MASTER BUILDERS
A U S T R A L I A

Thank you for the opportunity to make comment on the *NCC 2022 Public Comment Draft (stage 2)*.

NCC Public Comment Draft (Stage 2) Response Sheet

Clause/Figure/Table: J2D2(2)(b)(i)

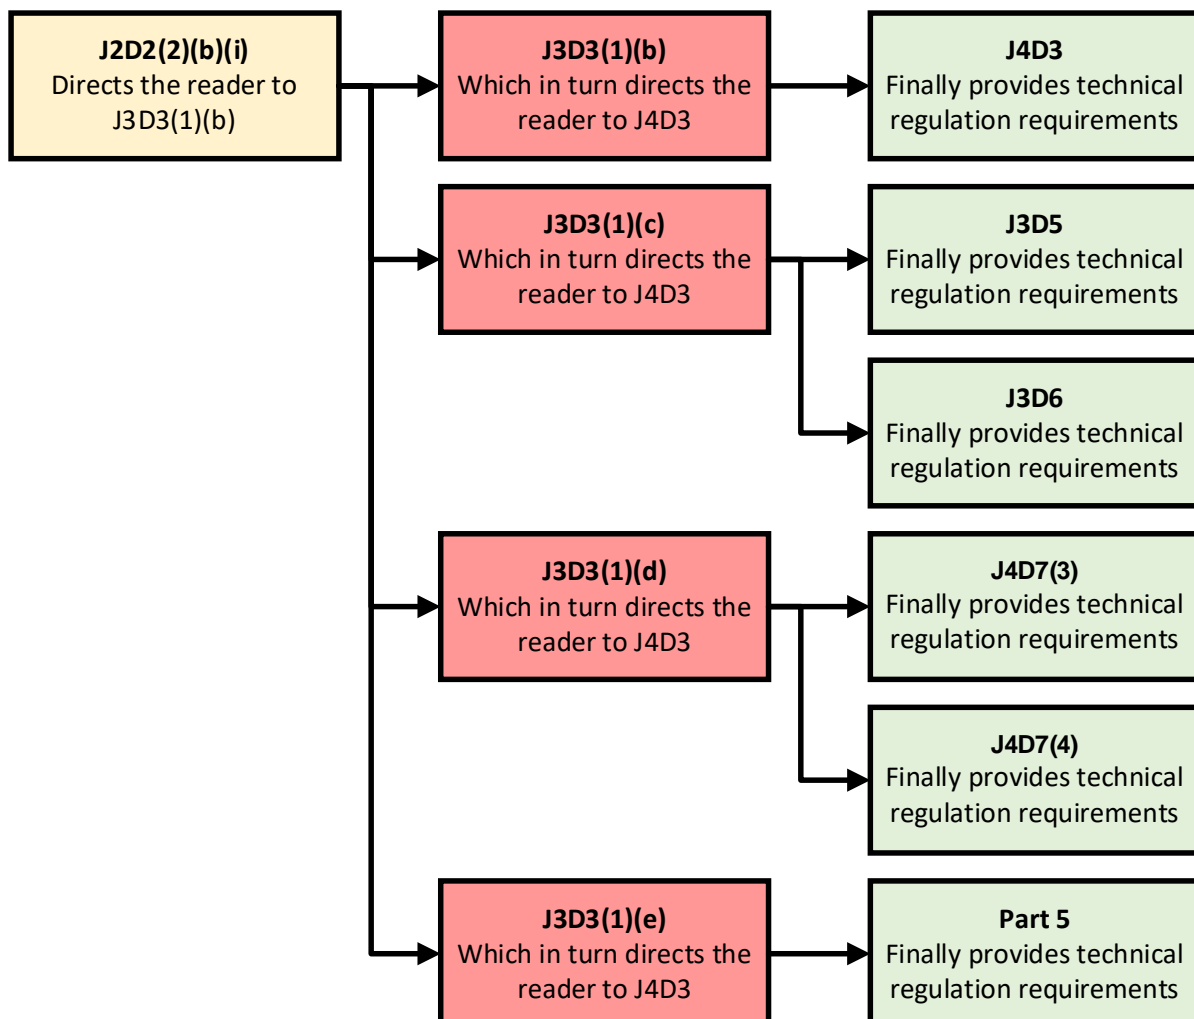
(i) for general thermal construction, ~~J3D3(1)(b) to J3D3(1)(e)~~: J4D3, J3D5, J3D6, J4D7(3), J4D7(4) and Part J5:
